**Critique of  
*The Future of the Nuclear Fuel Cycle:  
An Interdisciplinary MIT Study (2011)***

Developed by the Science Council for Global Initiatives  
Contact: Tom Blee, tomsciencecouncil@gmail.com

Figure 1. Radiological toxicity of LWR spent fuel constituents as a function of time

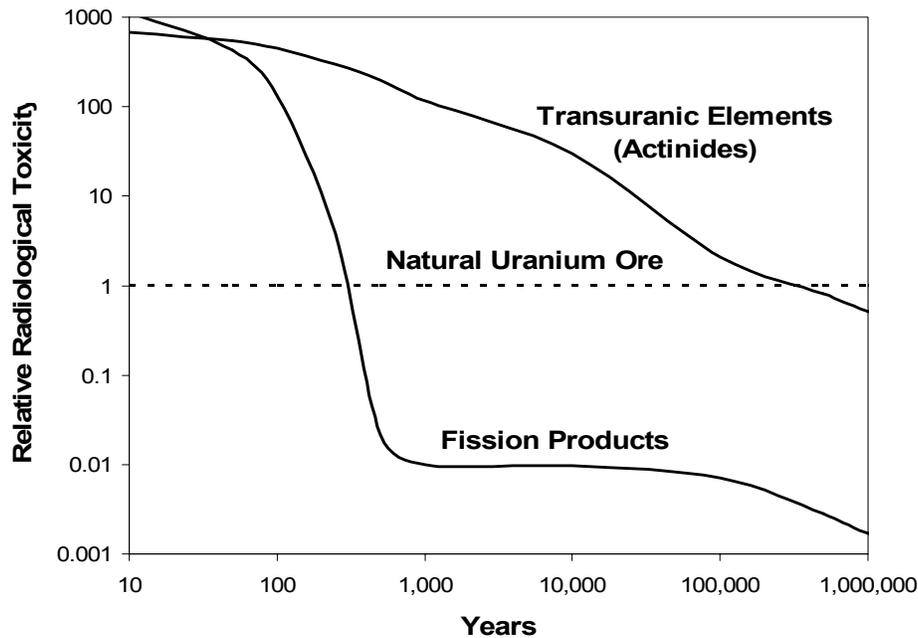
For all practical purposes, the radiological toxicity due to the fission product portion of the waste decays with (approximately) a 30 year half-life, due to the dominance of strontium and cesium isotopes. It drops below the natural uranium ore level in about 300 years, and becomes harmless in well under 1,000 years. On the other hand, the radiotoxicity level associated with the actinide portion stays far above that of natural uranium ore for a very long time, and remains at least three orders of magnitude higher than that for the fission products for hundreds of thousands of years. This is why following the National Academy of Sciences Committee recommendation, the EPA standards and NRC regulations for the Yucca Mountain repository extended the regulatory timeframe from the original 10,000 years to one million years.

The important point is this: if 99.9% of actinides could be removed from the waste form, then the radiological toxicity of the remaining 0.1% actinides would stay below the level of natural uranium ore at all times and the effective lifetime of the waste would be dictated by the fission products. If the actinides were mostly removed from the waste stream, the EPA standards and the NRC regulations [whether they cover 10,000 years or millions of years] can be met on an *a priori* basis.

Needless to say, this is an extraordinarily important fact, and the MIT Study ignored it.

Figure 2. Specific Inventory vs. Reactor Size (MWe)      Figure 3. Range of Breeding Ratios

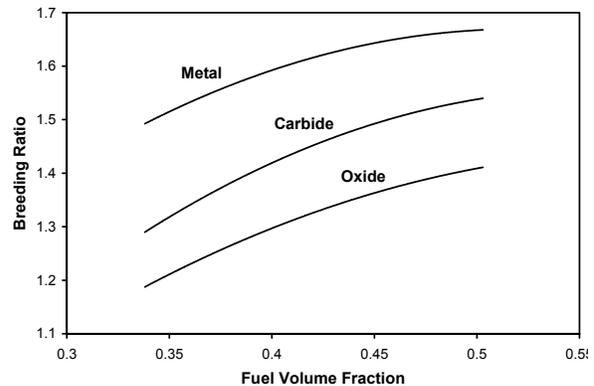
- The analysis used ALMR (PRISM Mod B) as the representative fast breeder reactor design, with a specific inventory (kg fissile material per megawatt electric) about a factor of two too high. The specific actinide inventory is presented here in Figure 2 as a function of the reactor size.

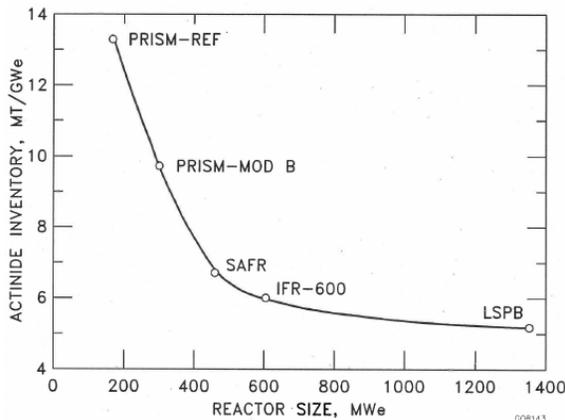
- A breeding gain of 0.23 was assumed, which is too low by a factor of two or three. The breeding ratio potential for what we'll call "advanced" fast reactors is presented in Figure 3 for various fuel types. Here, breeding ratio is the net gain in fissile material over some period of time, compared to the fissile loss from power generation. The metal fuel developed during the Integral Fast Reactor (IFR) program has become the reference fuel in the U.S. It has a breeding ratio potential in the range of 1.50–1.65. In the early years of deployment, the high breeding gain is not needed, but it is there from the start, and it can be used by simply deploying more  $U^{238}$  "blankets"—reflector regions actually—to capture a higher fraction of the neutrons leaving the core. If you don't need the plutonium early in fast reactor deployment, you would not load full blankets. A key advantage of the fast reactor design is that the plutonium production rate can be easily tailored to plutonium demand.

Figure 4. Example scenario for worldwide nuclear energy growth

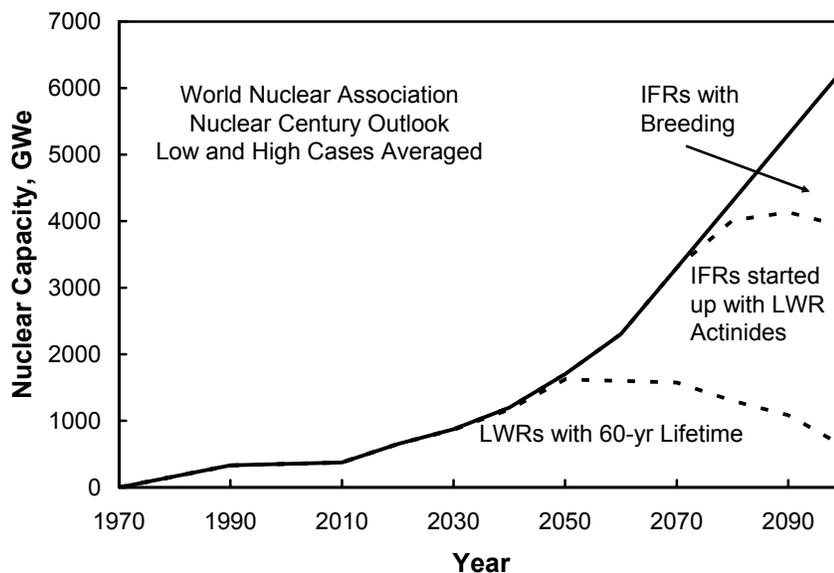
An example of nuclear fuel cycle system analysis more properly done is illustrated in Figures 4 and 5. These figures depict a scenario for world-wide nuclear energy growth, and the impact of fast reactors on the cumulative uranium requirement is very clear. The introduction of breeders can cap the LWR capacity (Figure 4) and hence also cap the ultimate uranium requirements (Figure 5). The divergence of the cumulative uranium requirements (Figure 5) will continue to widen if the plot is extended beyond 2100.
